CRIPPEN ACRES
GEOLOGICAL STUDY OF THE NIPAWIN
HYDROELECTRIC PROJECT
LETTER REPORTS
0093
AUGUST 5, 1983-FEBRUARY 15, 1984

In reply to your letter of July 25, 1983 (5151.18.02) requesting a geologic review of the Nipawin Hydroelectric Project, I am submitting the following final letter report.

Nipawin Hydroelectric Project
Geologic Review 0093-003

Nipawin Hydroelectric Project
Geologic Review 0093-004

DRAWING 0093-001-02. GEOLOGIC CROSS SECTION A-A', NIPAWIN HYDROELECTRIC PROJECT. SEE DRAWING 0093-001-01 FOR LOCATION.

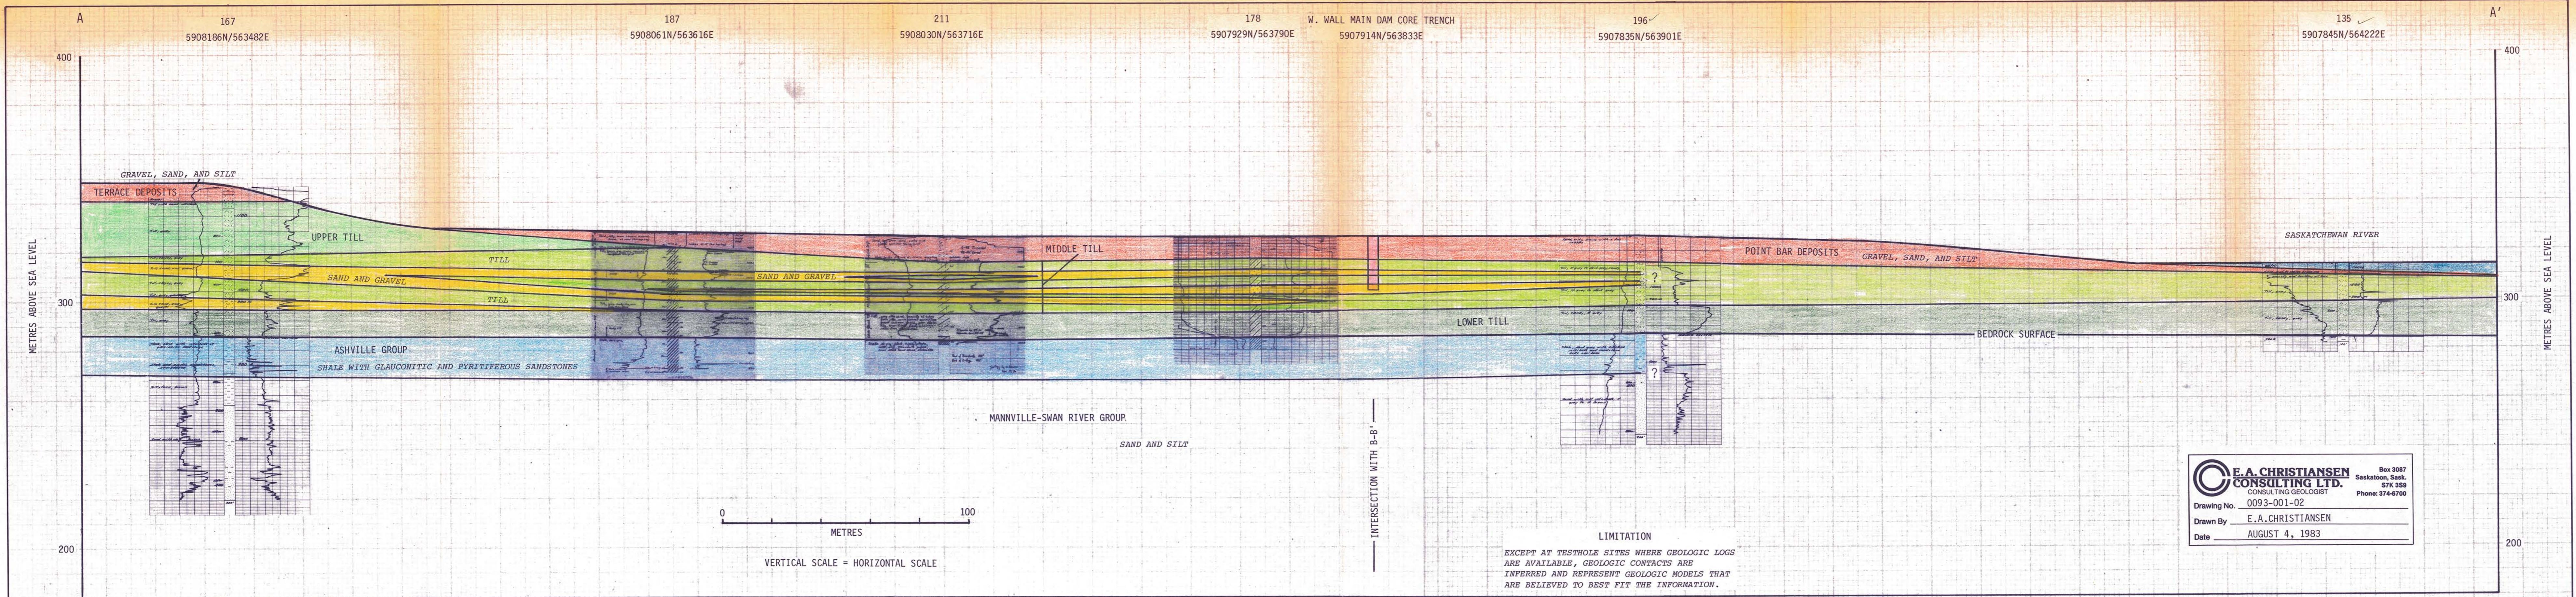
The top of vertical drain 120Y is probably in the sand and gravel unit as shown in testhole 172 (Drawings 0093-001-03,04). Vertical drain 557 should drain the lowermost sand and gravel unit as shown in Testhole 187 (Drawing 0093-001-02). Presumably the geology changes between the test-

hole and the drain accounting for the lack of flow. Vertical drains 505 and 532 near Testholes 194 and 189 (Drawing 0093-001-03,04) are in till beneath the sand and gravel units; consequently, these drains are dry. Vertical drain 544 near Testhole 211 (Drawing 0093-001-02) probably drains the lowermost sand and gravel unit.

From the above sample of testholes near the tunnel, it appears the vertical drains were not extended high enough above the tunnel to effectively drain the intertill sand and gravel units.

Figure 1. Drill hole log 363 (R-5) showing carbonate and textural analyses.

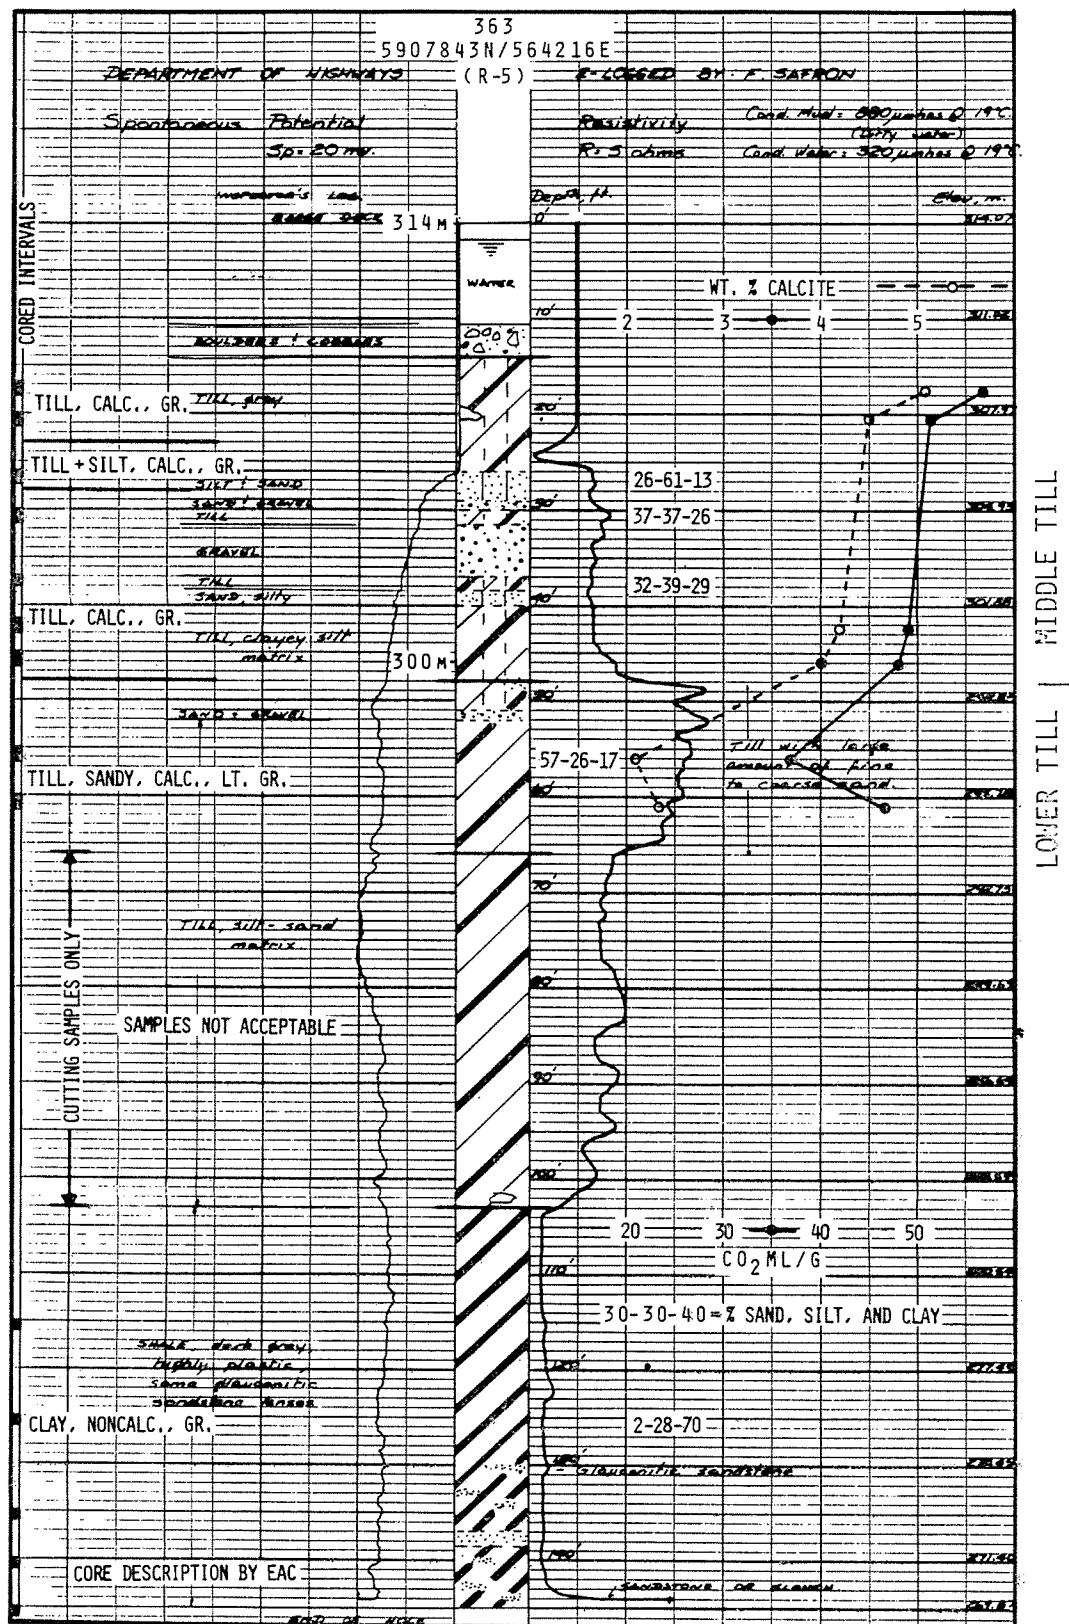
The information obtained from R-5 is incomplete for the following reasons: (1) the cased interval was not gamma-ray logged; (2) the Inspector's log does not agree with the electric log between 26 and 40 feet; (3) the cutting samples (66 to 103 feet) were bagged wet and, consequently, the nature of the sediment could not be determined; and (4) a definite bedrock marker bed was not penetrated.

To identify the lithology of the till in R-5 (Fig. 1), 6 carbonate and 4 textural analyses were determined. The Lower Till has a calcite content of about 2%, whereas the Middle Till has more than 4%. The Lower Till is sandy, whereas the Middle Till has about an equal proportion of sand, silt, and clay. In hand specimens the Lower Till is more sandy and is light

To complete cross section CC' (Drawing 0093-001-04, letter report of July 30, 1983), I propose to draw a cross section from DH 194 through R-3,2,1, 4,5,6, LA1, DH 198, to UA 2. I would also recommend a testhole be drilled in the vicinity of the east end of TR1. LA1 should be drilled into the Swan River Formation to make up for R-5 which did not penetrate a definite bedrock marker.

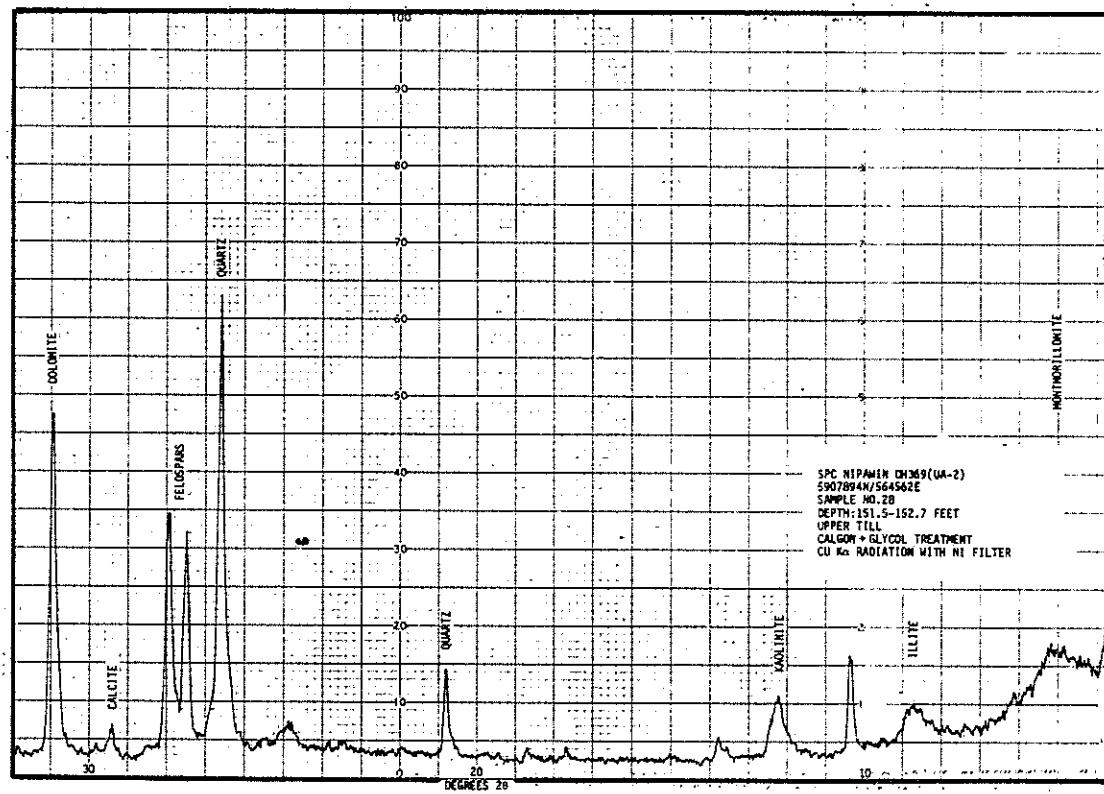
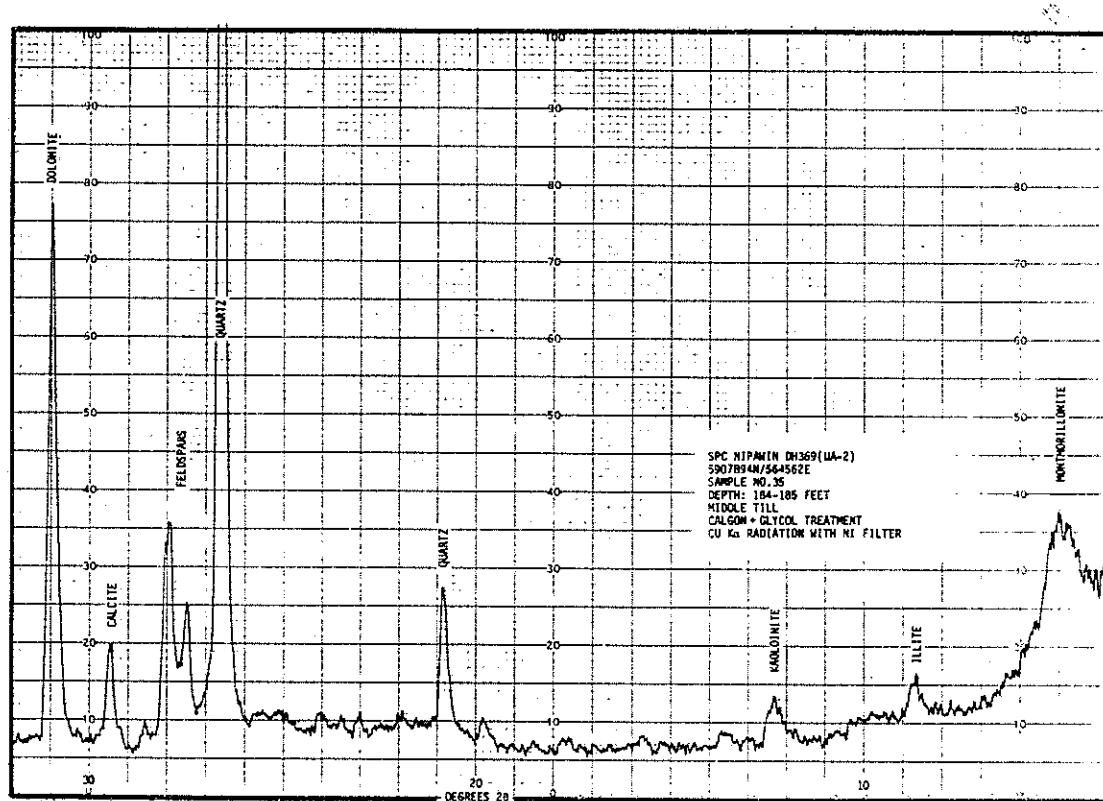
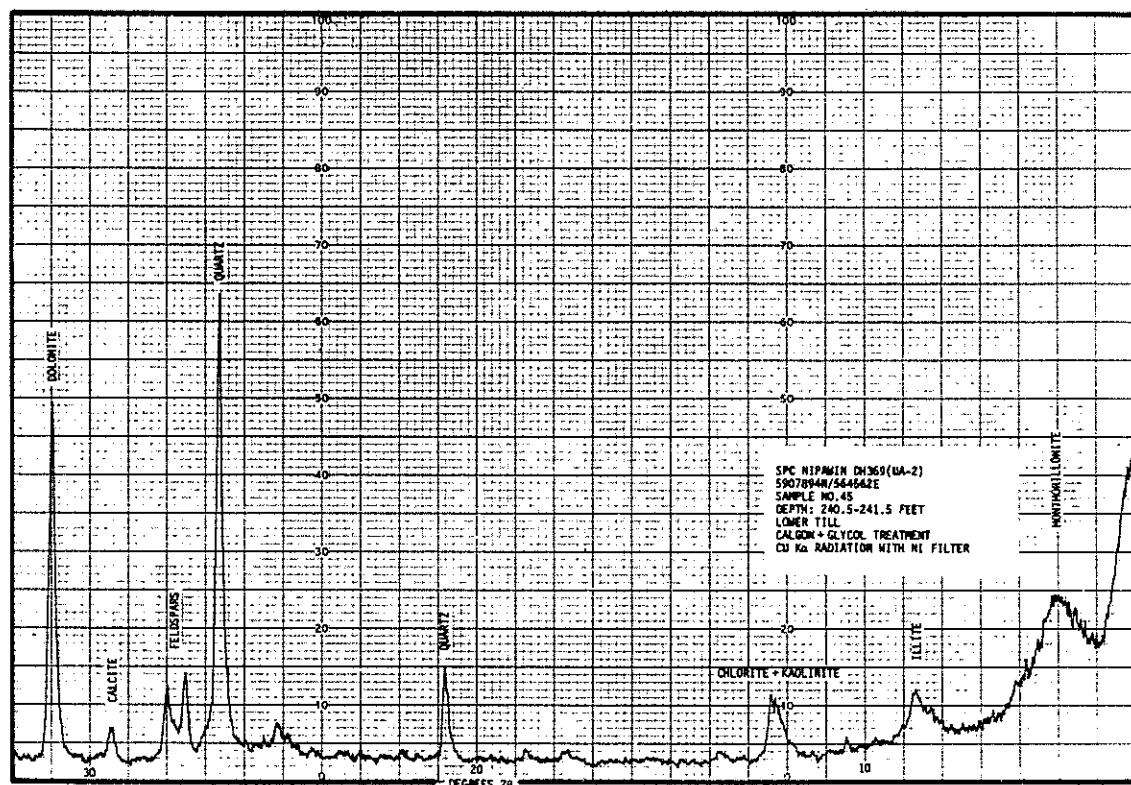
The Upper and Middle tills in UA2 (Drawing 0093-004-03) can be readily separated on carbonate content and texture. The Upper till has a lower carbonate content and is more sandy and less silty than the Middle till. Although the Middle and Lower tills have similar carbonate content, the Middle till is more silty and less sandy than the Lower till. All tills have a similar mineral content (Figs. 1-3).

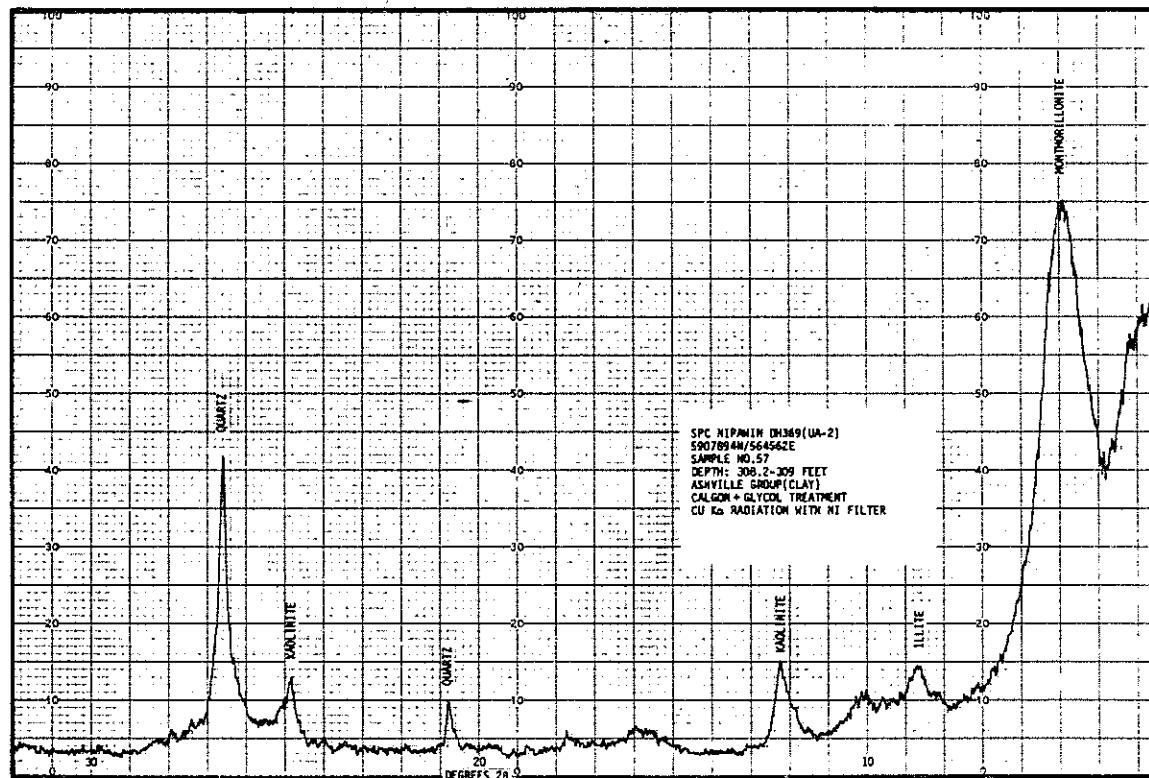
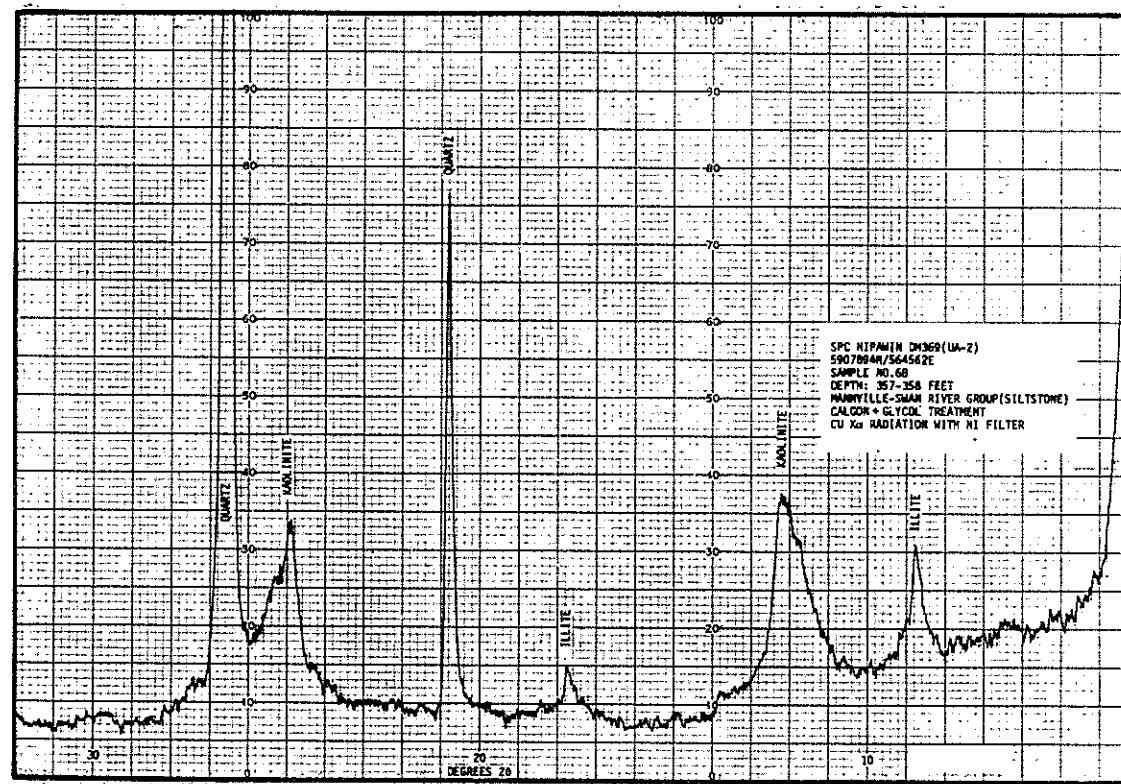
The Ashville and Mannville - Swan River Groups can be readily separated on color, texture, and clay mineral content. The Ashville Group is composed of

dark gray, highly montmorillonitic clay and shale (Drawing 0093-004-03, Fig. 4), whereas the Mannville - Swan River Group is composed mainly of light gray, kaolinitic silt and siltstone (Drawing 0093-004-03, Fig. 5).
